CERTIFICATE OF APPROPRIATENESS

Property: 1245 Cortlandt Street, Lot 1, Block 188, Houston Heights Subdivision. The property includes a historic 1,512 square foot, one-story wood frame single-family residence and a detached garage situated on a 6,600 square foot (50' x 132') corner lot.

Proposal: Project Type – Construct a 2-story rear addition to a one-story corner residence.

Recommendation: Denial - does not satisfy criteria: 1, 4, 8, and 9

WEST (REAR) ELEVATION

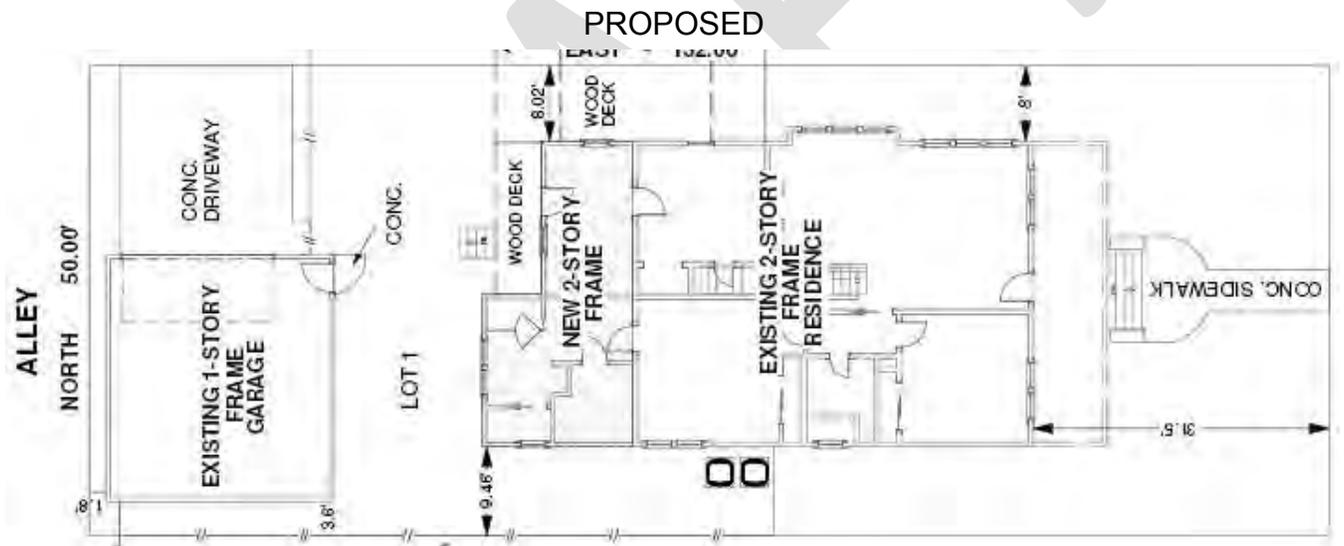
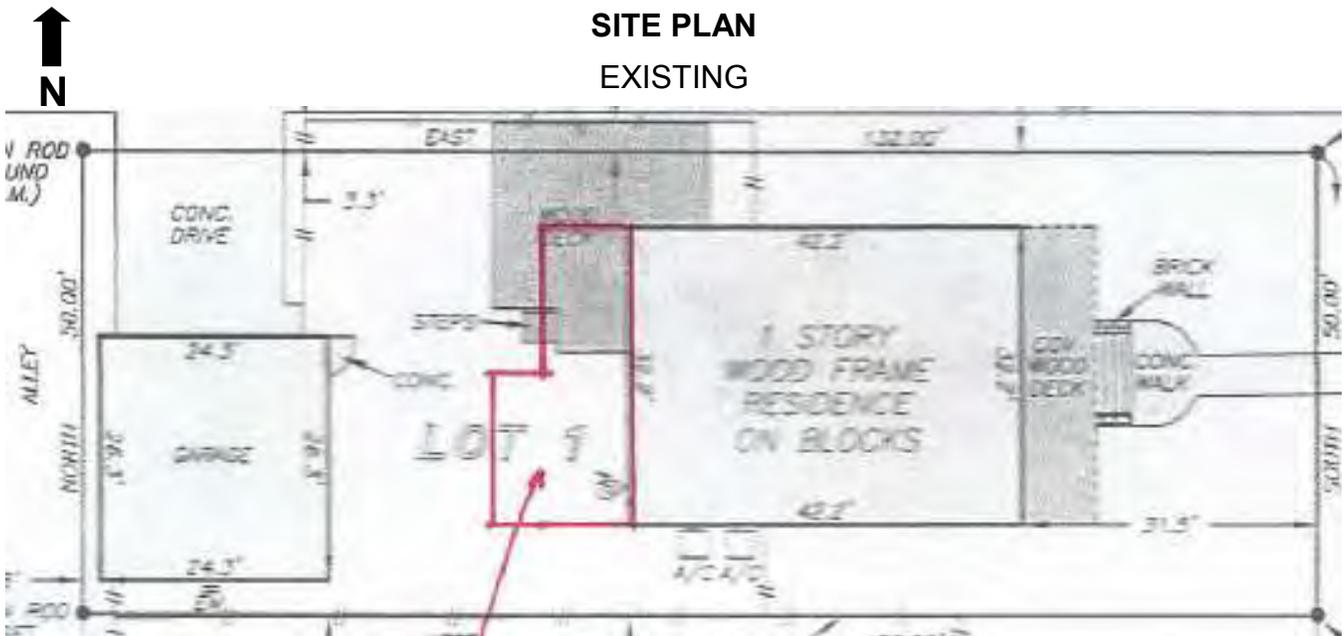
<i>The proposed addition encroaches 5' on the existing residence which results in the alteration of the existing hipped roof which is a distinguishing character of the residence. The encroachment onto the existing residence will result in the loss of significant historic material due to the walls being reframed to carry the load of the second-story addition.</i> |

ROOF PLAN

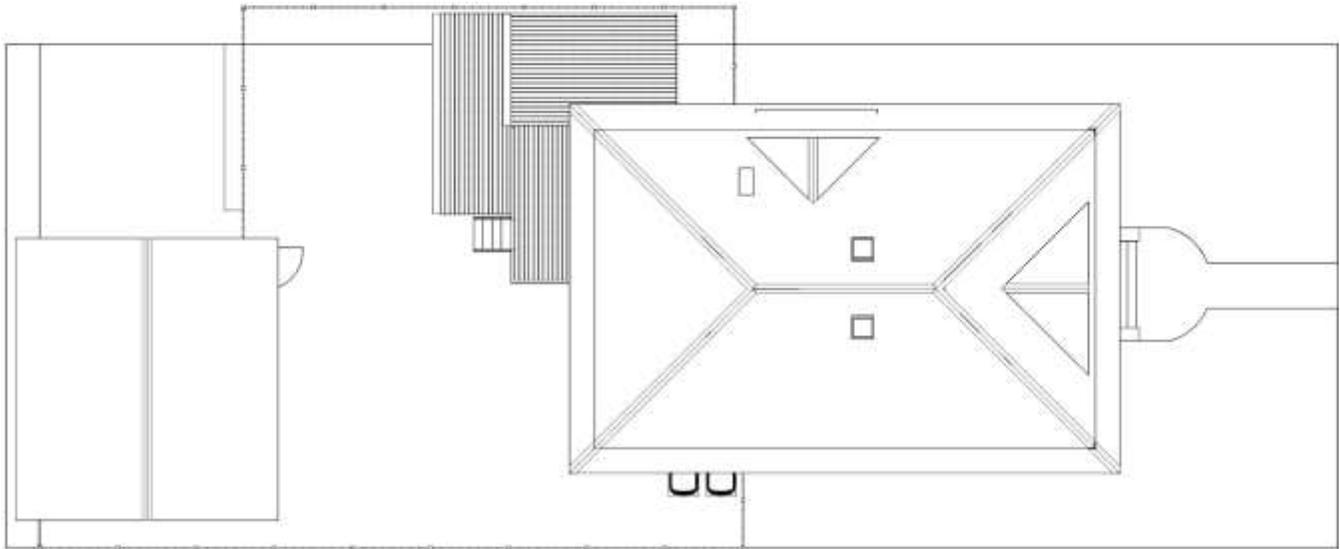
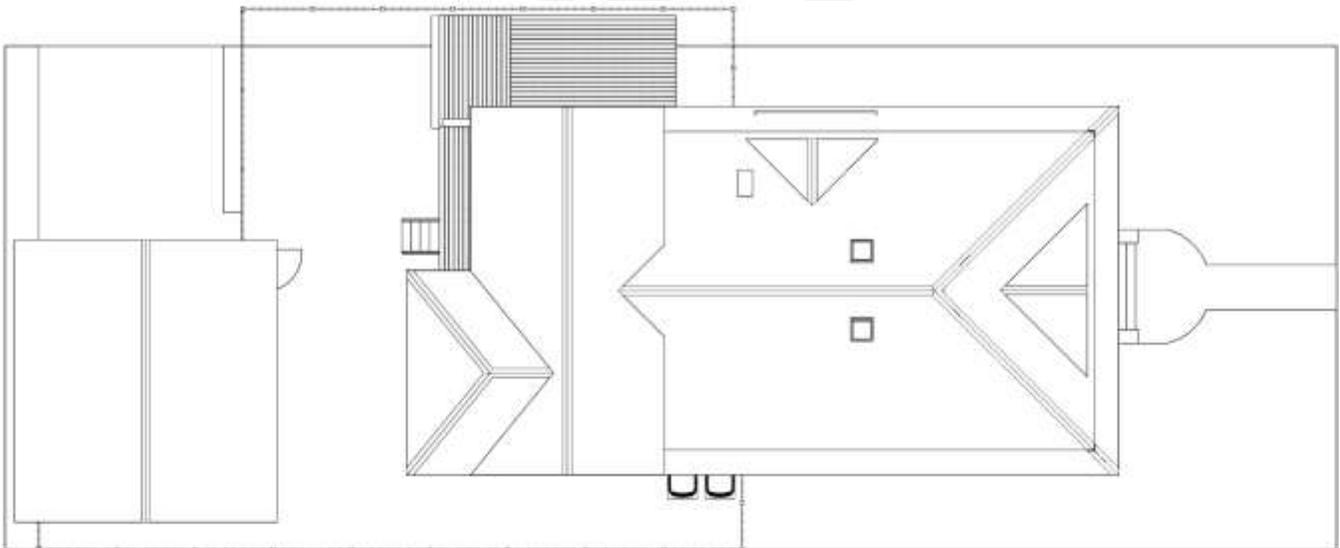
<i>The proposed addition encroaches 5' on the existing residence which results in the alteration of the existing hipped roof which is a distinguishing character of the residence. The addition is highly visible due to the residence being located on the corner of Cortland Street and E 13th Street and overwhelms the historic character of the 1910 Craftsman Bungalow.</i> |
